REMARKS

Claims 1 - 4 and 9 - 15 remain active in this application. New claims 16 and 17 have been presented. Claims 5 - 8 have previously been canceled. Claims 1 and 9 have been amended to even more clearly define the subject matter regarded as the invention and to emphasize errors in the grounds of rejection asserted in the present action. Support for the amendments of the claims is found throughout the application, particularly in the specification at pages 20 and 23. Support for new claims 16 and 17 clearly appears in Figure 1 of the drawings, as originally filed. No new matter has been introduced into the application.

FIG. 8
PRIOR ART

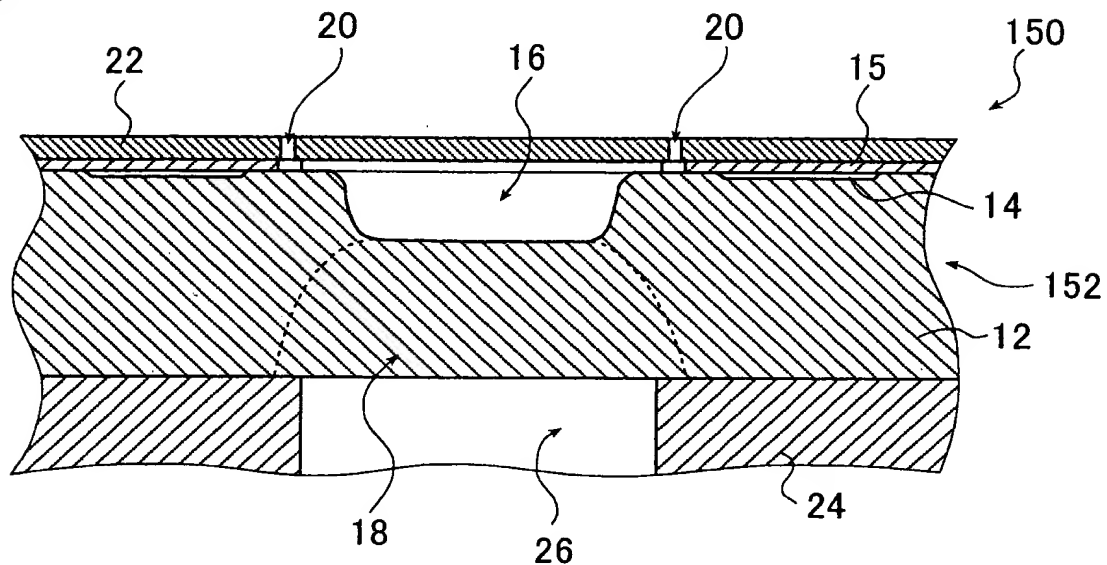
Additionally, claims 1, 3, 9, 11 and 13 - 15 have been rejected under 35 U.S.C. §103 as being unpatentable over the admitted prior art of Figure 8 in view of Nagahata et al. and claims 2, 4, 10 and 12 have been rejected under 35 U.S.C. §103 as being unpatentable over the admitted prior art of Figure 8 in view of Nagahata et al. in view of Gaynes et al. These grounds of rejection are also respectfully traversed. It is noted, for the record, that these grounds of rejection are essentially repeated from several prior actions with Nagahata et al. substituted for Kitahiro, previously applied and now overcome.

While the Examiner's observations concerning the structure illustrated in Prior Art Figure 8 are substantially correct, it is respectfully submitted that the admitted prior art does not extend to recognition of the problem addressed by the invention or recognition of the likelihood of success in achieving a solution to that problem by providing a metal film on a portion of a side of the head body in accordance with the present invention. Therefore, it is respectfully submitted that the admitted prior art cannot supply motivation for the *modification* of the admitted prior art, as claimed. Accordingly, it is respectfully submitted that the Examiner's statement that the admitted prior art "teaches the claimed invention with the exception of a metal film on a part of at least one side of the head body" may be somewhat of an overstatement to the extent that it may infer that the prior art includes recognition of a need for the addition of a metal film or any other expedient to avoid cracking or propagation of cracks in the prior

art structure. That is, any motivation for any proposed modification of the admitted prior art structure cannot be derived from the admitted prior art structure except through impermissible hindsight in light of the present specification.

In any case, the Examiner admits that the admitted prior art does not teach or suggest the provision of "a metal film at least on a part of at least one side of said head body" and relies on Nagahata et al. to supply such a teaching and motivation for its inclusion in combination with the admitted prior art head body structure and it is respectfully submitted that Nagahata et al. does not do so. Nagahata et al. discloses a "support plate 18" (emphasis added) which is intended to function as a heat sink for the substrate as well as to "reinforce" the substrate and acknowledges that the substrate is "relatively brittle" (column 8, lines 44 - 48, as noted by the Examiner). However, in the immediately following text of Nagahata et al. it is noted that support plate 18 can be provided as part of the print head or as part of the printer, to which the print head may be later attached. Further, the immediately following text in column 8, lines 58+, indicate that the head substrate 2 is preferably attached "only at a longitudinally central portion of the substrate" to prevent thermal bending due to differential thermal expansion between plate 18 and substrate 2 being imposed on substrate 2. It should also be noted that the disclosed function of plate 18 as a heat sink favors increased thickness of the plate structure to reduce thermal resistance of the thermal path and that the imposition of thermal bending is a function of the relative thickness of the substrate and the plate since the forces developed by thermal expansion are a function of the cross-sectional area in a plane perpendicular to the direction in which thermal expansion is resisted by another structure to

FIG. 9A
CONVENTIONAL ART
152(30)

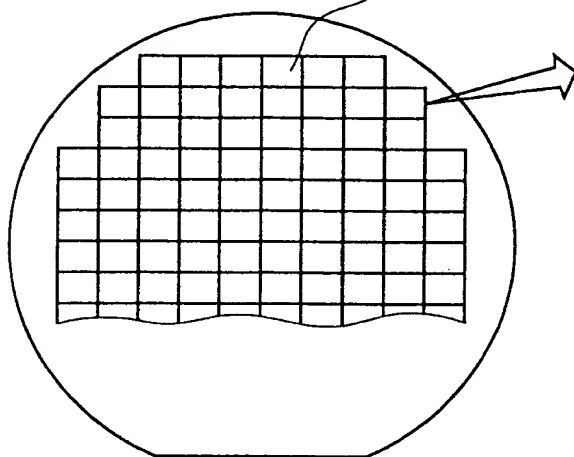
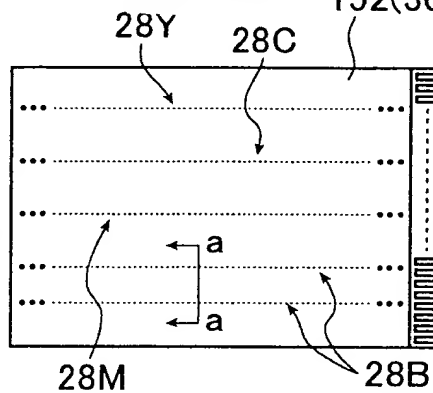
The Examiner has repeated the objection to the proposed drawing revisions which seek to label Figures 9A - 9C as "Related Art" instead of "Prior Art" insisted upon by the Examiner. This objection is again respectfully traversed, particularly since the Examiner's observation that the Figures are "identified in the specification as illustrating conventional art" is respectfully submitted to be in error.

Specifically, the discussion of Figures 9A - 9C on page 4 of the specification has been reviewed and no reference to these Figures as "conventional" is seen. As previously pointed out, while the word "conventional" is used in the statement of the Brief Description of the drawings, the context is:

"Figures 9A, 9B and 9C are *conceptual* views for *explaining* the inkjet recording head of the present invention *and* the conventional inkjet recording head."
(emphasis added).

The clear import of this passage is that the illustration is *conceptual* and not of any particular known device and that it is not exclusively limited to that which is conventional while not necessarily including or excluding the invention. Therefore, since the Examiner must consider everything the Applicant has said about the prior art to determine the scope of any admission, as noted in *In re Nomiya*, previously cited, the Examiner may not misconstrue the above statement to force an admission which might contradict the above statement in the specification.

Nevertheless, to expeditiously resolve the issue, approval has been requested, above, to label Figures 9A, 9B and 9C as "Conventional Art" as the Examiner has required. Accordingly the objection and requirement have been rendered moot and reconsideration and withdrawal of the same is respectfully requested.
